Z18-0060

MEMORANDUM

Subject: 2053 Union Rd, 148 Summerhill PL Plan KAP56062 Lot M,N 5 oţ

Re: 148 Summerhill Place & 2053 Union Road, Plan KAP56062 Lot N & M facilitate a proposed 5 lot Subdivision. (Z18-0060 DVP18-0114 S18-0046) A rezoning application to rezone the subject property from A1 to RU2 & RU6 to

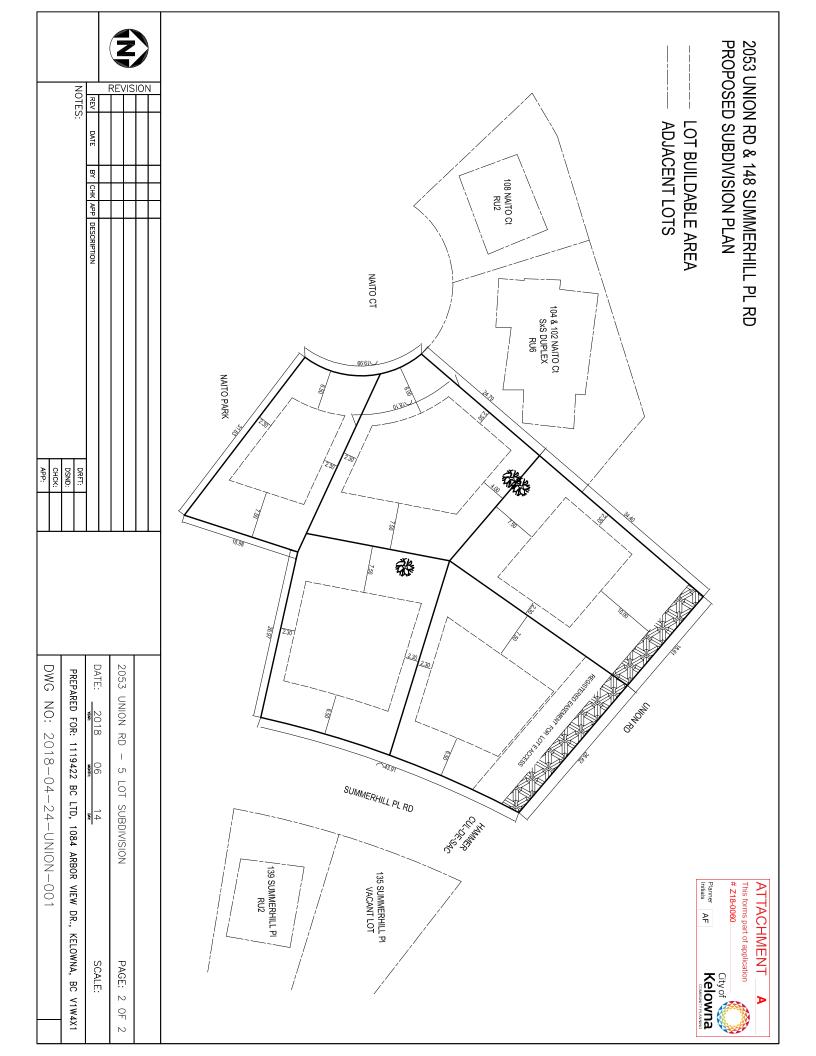
DEVELOPMENT VARIANCE PERMIT (DVP) IS REQUIRED. MINIMUM 18m FRONTAGE IS REQUIRED FOR THE PROPOSED TWO DWELLING HOUSING ON LOT E.
